CENTRE POINT  
PLANNING COMMENTS RESPONSE  
DOCUMENT 552-7101

22ND AUGUST 2012

This document highlights the proposed changes.

REV PL1 EAST ELEVATION

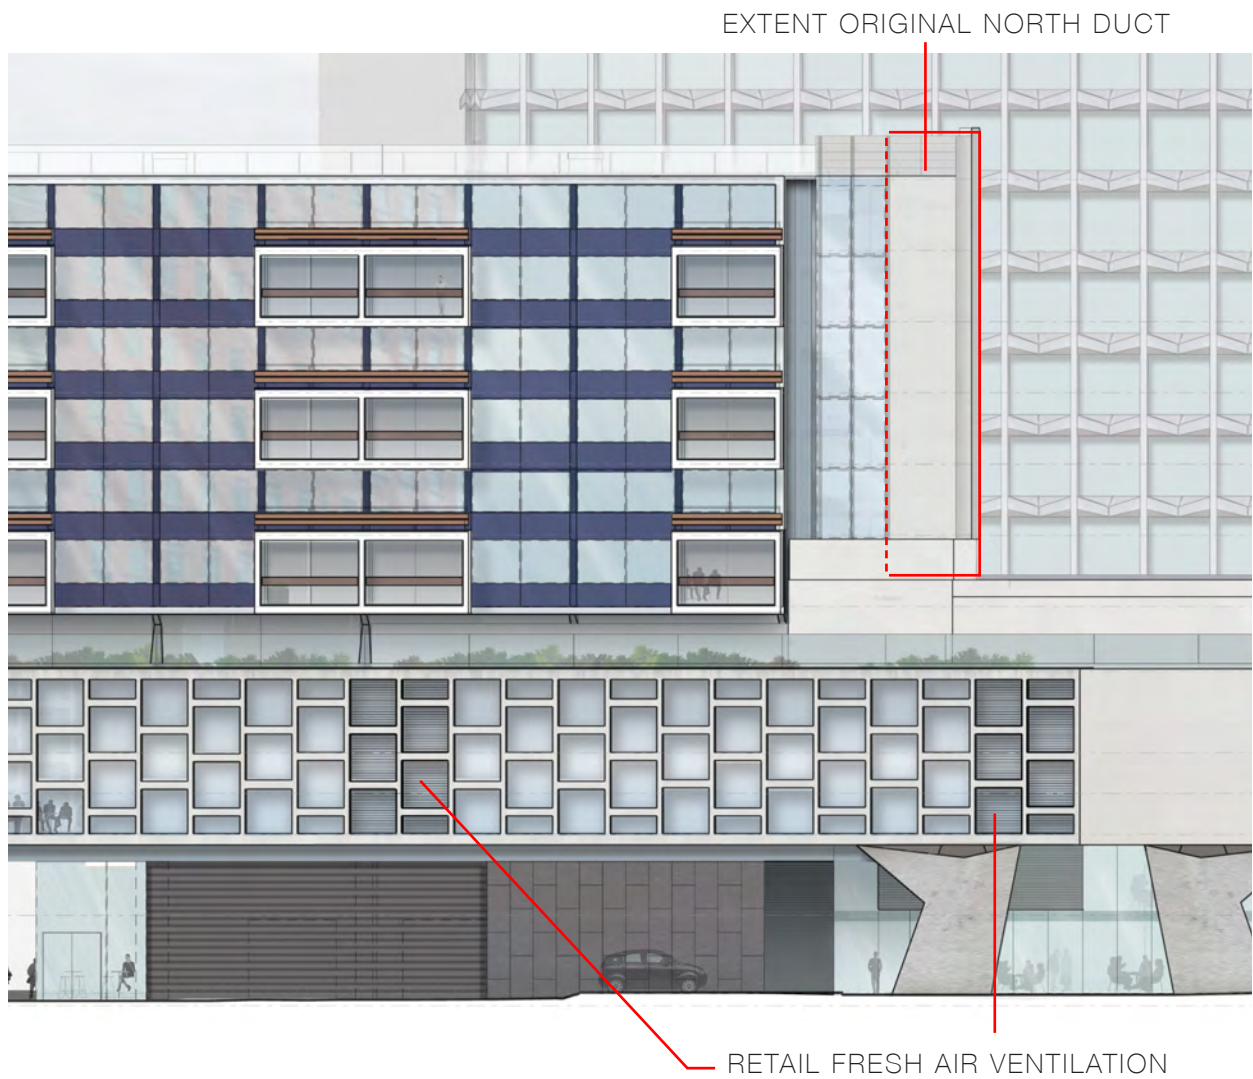
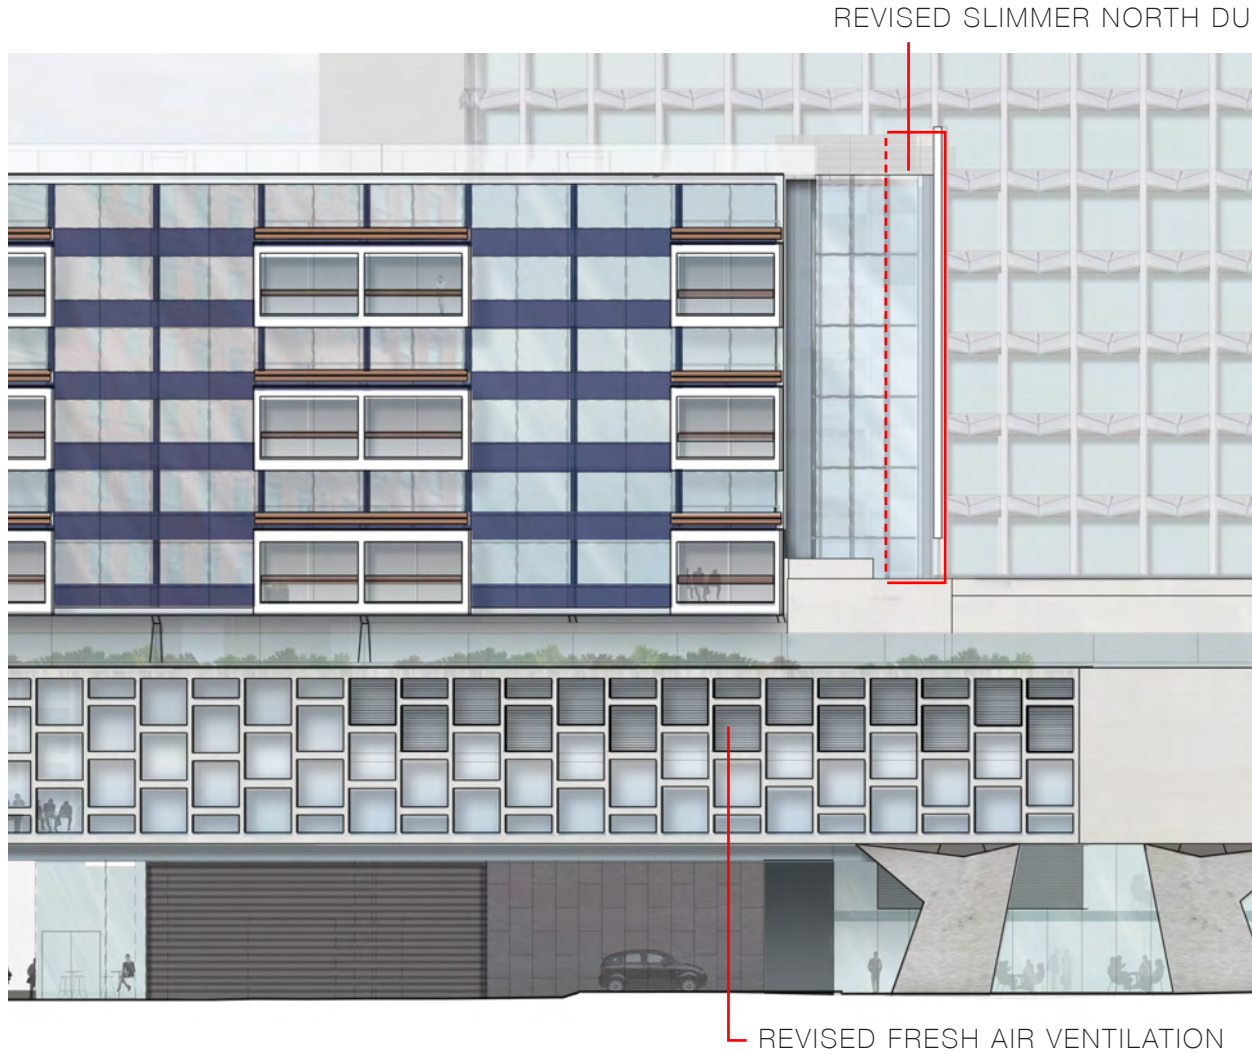
3. Design development of the ventilation duct to north side of Centre Point House. This has allowed the overall volume of the addition to be reduced to a more slender element. In addition a glazed 600mm wide slot has been introduced to preserve the sculptural quality but add more detail and articulation to the two planes to enliven the facade. Glazing areas have also been increased at the two sides of the plane.

REVISED PROPOSAL (REV PL2) - REDUCED DUCT SIZE
